Proposed Amendment 160

Justification for Proposed Exemption Request
From Requirements of 10 CFR 50.60, 10 CFR 50.61
and
Appendices G and H to Part 50

Proposed Amendment 160

Proposed Amendment No. 160 to the KNPP Technical Specifications

FIGURE TS 3.1-1

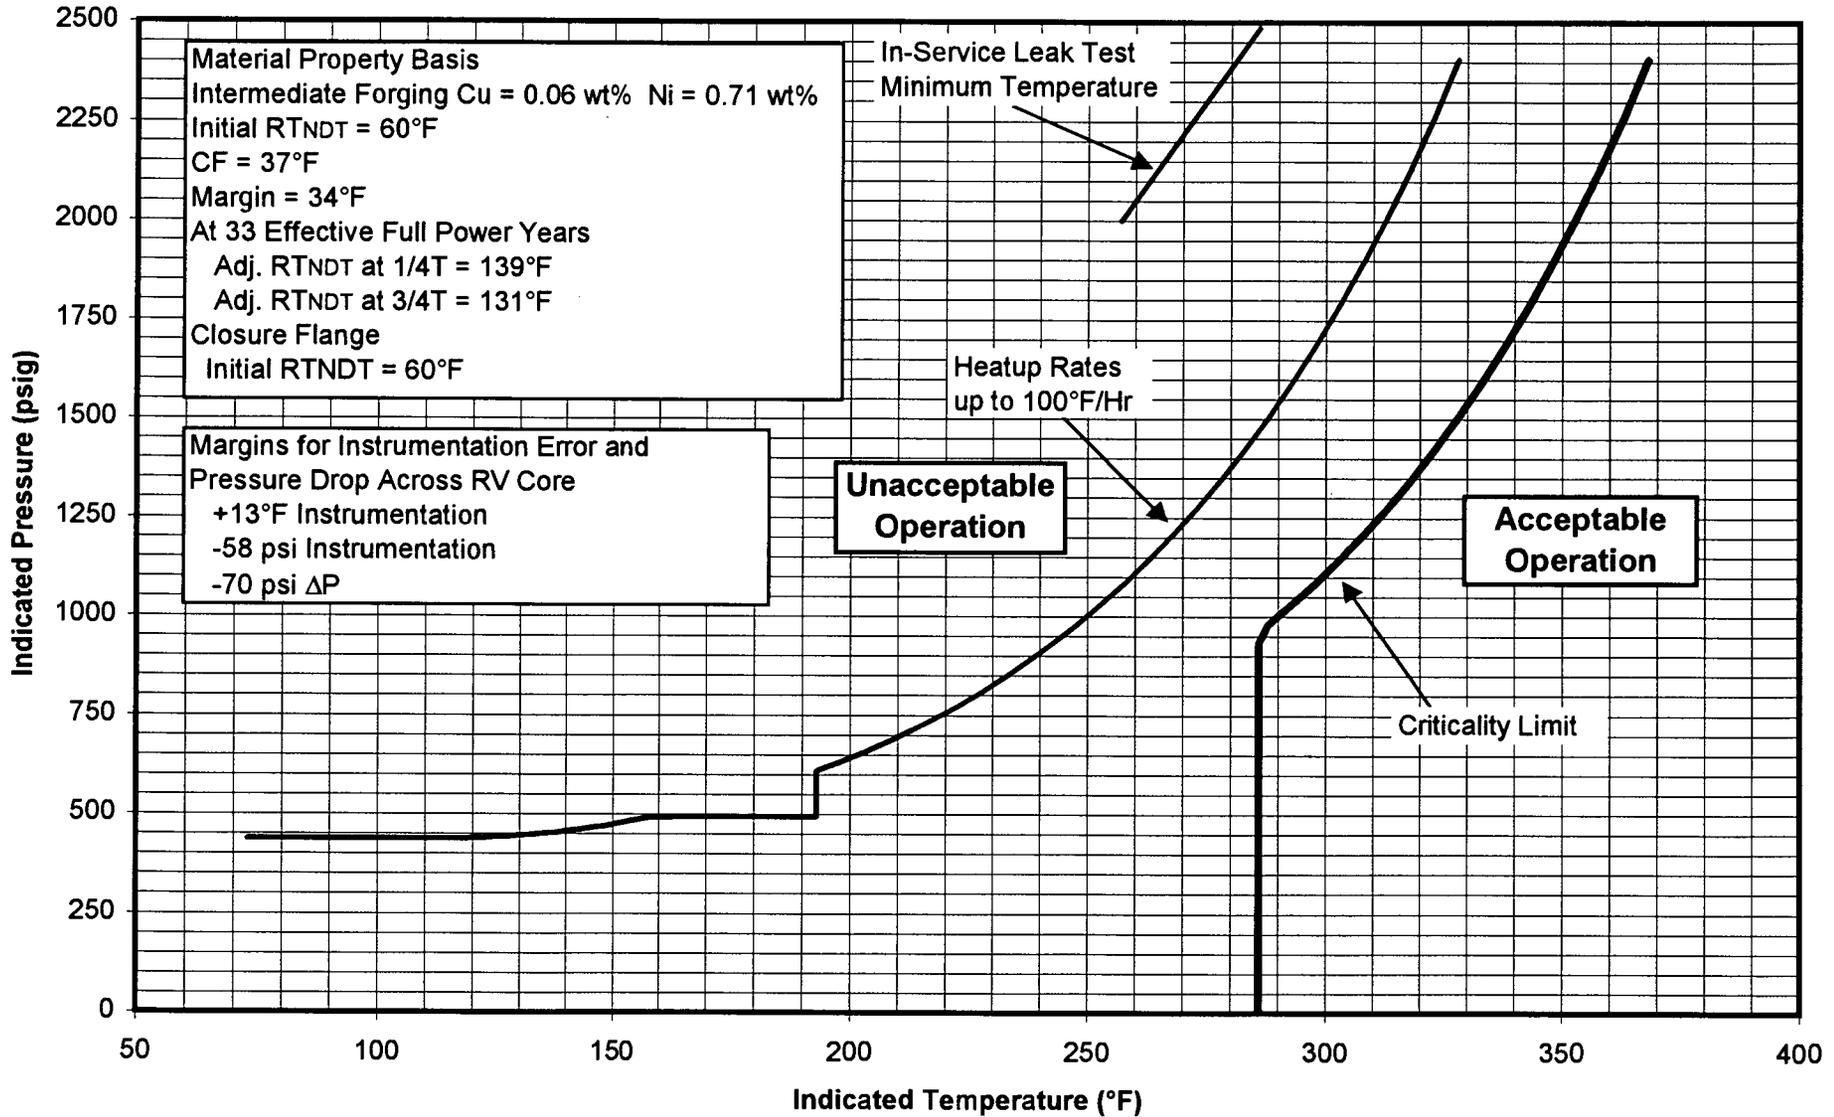
- 1) TS 3.1.b.1 is modified to reflect applicability of Figure TS 3.1-1 and Figure TS 3.1-2 for the service period up to 33 effective full-power years. This makes TS 3.1.b.1 consistent with the expiration date noted on the revised heatup and cooldown limit curves.
- 2) Figures TS3.1-1 and TS 3.1-2 have been modified to define 10 CFR 50 Appendix G pressure temperature limitations applicable for the service period of up to 33 effective full power years.
- 3) Basis Section 3.1 has been revised accordingly.

- 4) The List of Figures has been modified to reflect a new expiration date of 33 effective full power years for Figure TS 3.1-1 and Figure 3.1-2.

PA 160 extends application of the Appendix G heatup and cooldown limits from 28 EFPY to 33 EFPY. With NRC approval to use ASME Code Cases N-588 and the exemption requested in attachment 1, the allowable combination of pressure-temperature for the cooldown limits is marginally greater than the current limits. This TS amendment does not affect the current LTOP setpoint, LTOP system enabling temperature, or allowable combination of pressure-temperature for the heatup limits. However, this TS amendment does extend the applicability date for the current LTOP setpoint, LTOP system enabling temperature, and allowable combination of pressure-temperature for the heatup limits from 28 EFPY to 33 EFPY. The LTOP setpoint, LTOP system enabling temperature, and allowable combination of pressure-temperature for the heatup limits in the current TS's were limited to 28 EFPY by Reference 2. The technical content of this proposed amendment is identical to PA 157 for the LTOP setpoint, LTOP system enabling temperature, and allowable combination of pressure-temperature for the heatup limits.

FIGURE 3.1-1

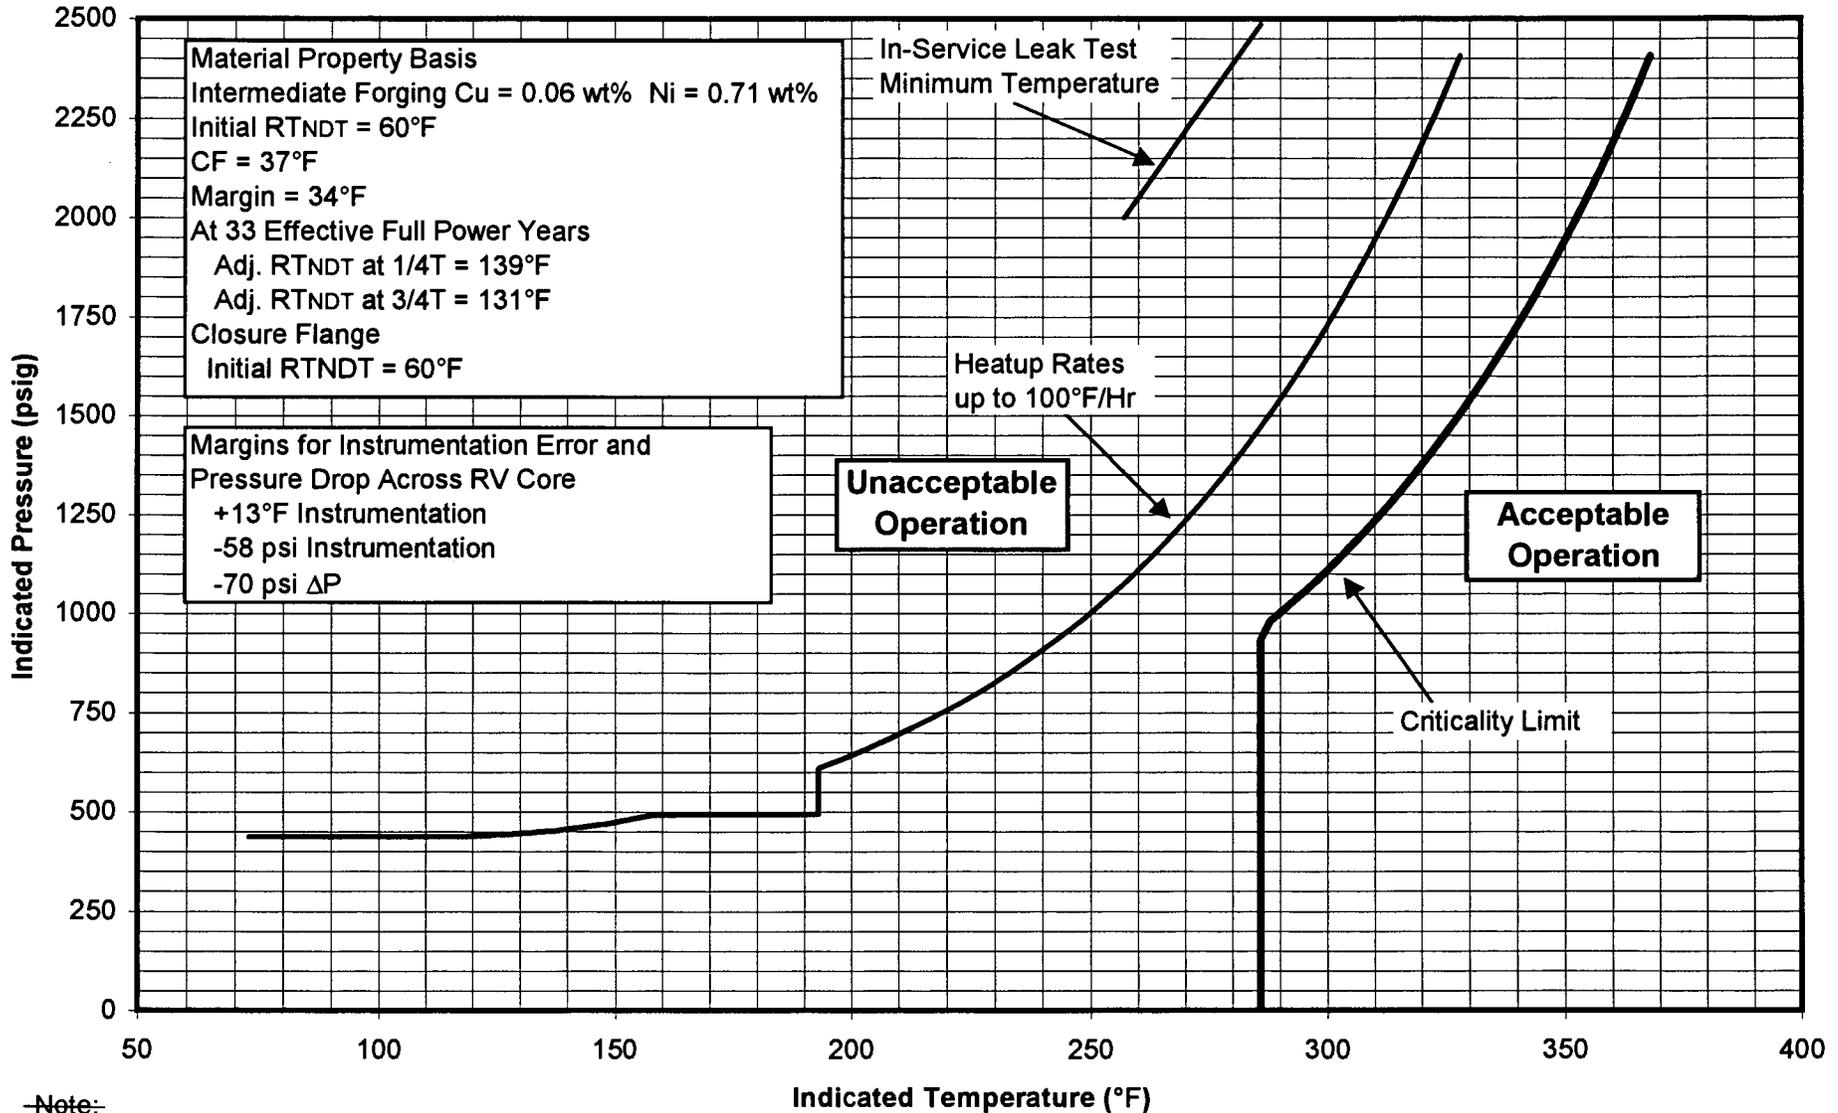
^(†) Although the curves were developed for 33 EFPY, they are limited to 28 EFPY—
 (corresponding to the end of cycle 28) by WPSC Letter NRC-99-017.
